PUBLIC HEARING MEMORANDUM

SUBJECT: **Petition #299-24** Request to amend Special Permit #240-23 to extend a nonconforming side setback, at 290 Watertown Street, Ward 1, Newton, on land known as Section 11 Block 14 Lot 03, containing approximately 11,473 sq. ft. of land in a district zoned BUSINESS 1. Ref: 7.3.3, 4.4.1, 4.1.2.B.3, 4.1.3, 5.1.4, 5.1.13 of Chapter 30 of the City of Newton Rev Zoning Ord, 2017.

290 Watertown Street

*290 WATERTOWN STREET
NEWTON
MASSACHUSETTS*

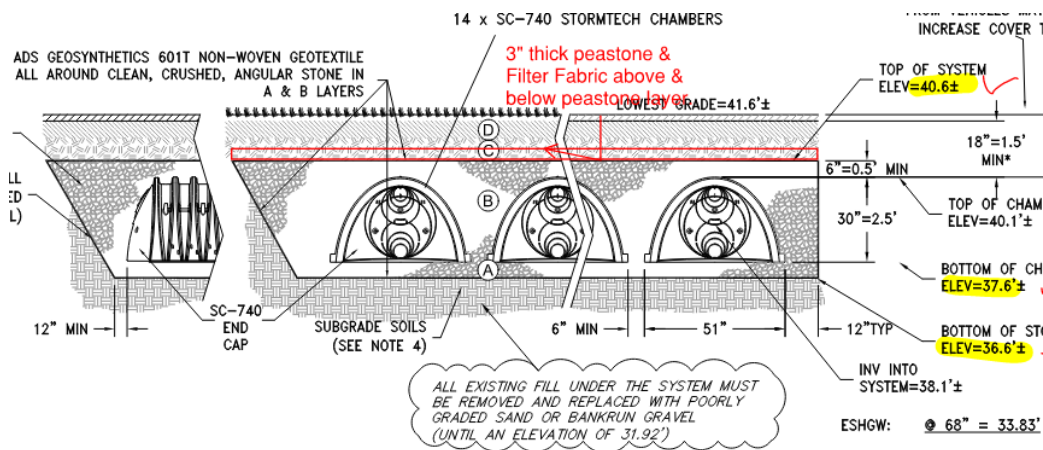
This proposed permit entails the demolition of an existing two-family unit and the construction of a 5-unit residential dwelling. The site has 60-feet of frontage along Watertown Street to the north, and residential dwellings to the south, east and western property lines. The site plan has a north arrow that is incorrectly rotated 180°. A high point elevation of 47-feet is near the front of the home and slopes gently to the northwest to a low point of 39-feet. The new dwelling will have on grade garages, a turning template plan should be submitted to demonstrate proper

The engineer of record has designed a stormwater collection system that meets the DEP & DPW Stormwater Regulations by collecting and infiltrating runoff from the driveway & roof within 14- infiltration units along the western & northern property lines. The proposed Operations & Maintenance (O&M) plan is acceptable for the design intent, however access to the units maybe problematic. A minor addition is need for the proposed infiltration system; the City requires a 3" thick layer of peastone with filter fabric above & below the peastone covering the entire system as shown below.

1. A construction management plan is needed for this project. At a minimum, it must address the following: staging site for construction materials and equipment, parking for construction workers vehicles, phasing of the project with anticipated completion dates and milestones, safety precautions, emergency contact personnel of the general contractor. It shall also address anticipated dewatering during construction, site safety & stability, siltation & dust control and noise impact to abutters.
2. Stabilized driveway construction entrance(s) will be required for the duration of the construction which will provide a truck wash to prevent tracking of mud and silt onto City streets.
3. Catch basins within and downstream of the construction zone will be required to have siltation control installed for the duration of the project and must be identified on the site plan.
